NRL Report No. B-1884

Report of Test

Gun Firing Transformer Type
GF, 200 V. A.

The Standard Transformer Company

PLATE 2

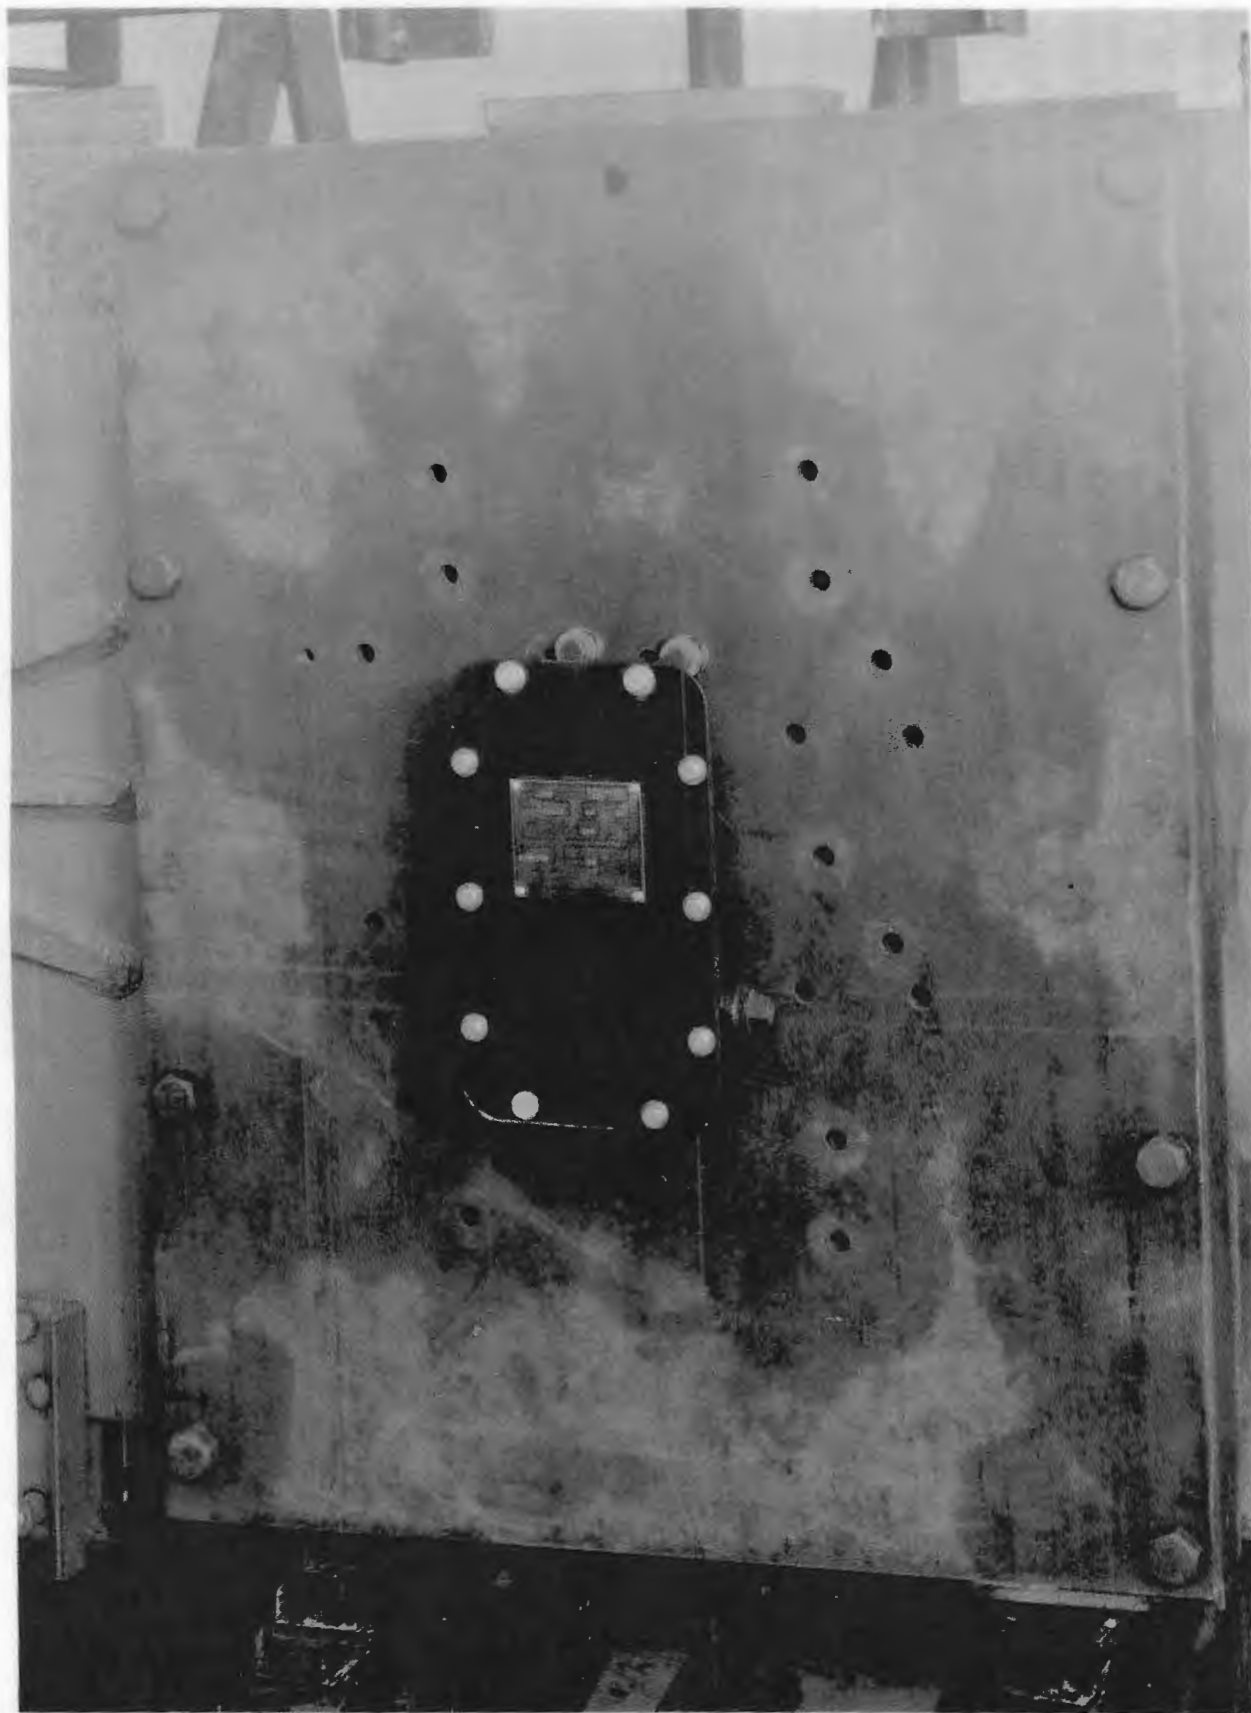
2. There is no adequate protection against the shorting together of adjacent terminals. As received, the secondary of the transformer was shorted at the rear of the terminal strip from this cause.

3. The core is not actually clamped between the steel pads and securing clamps as described in paragraph 6 of this report and as is obviously intended. Instead, as the pads welded into the back of the case are too thin by approximately $3/16$ " , they do not contact or support the transformer core but allow the winding to contact the rear wall of the case.

4. The core and winding assembly was dislodged and the terminal strip was broken by the second horizontal blow of the H. I. shock test. Prior to this, the transformer had withstood two side blows in addition to the first horizontal blow. Following two vertical blows, the upper left mounting screw sheared off. The enclosing case sustained no damage.
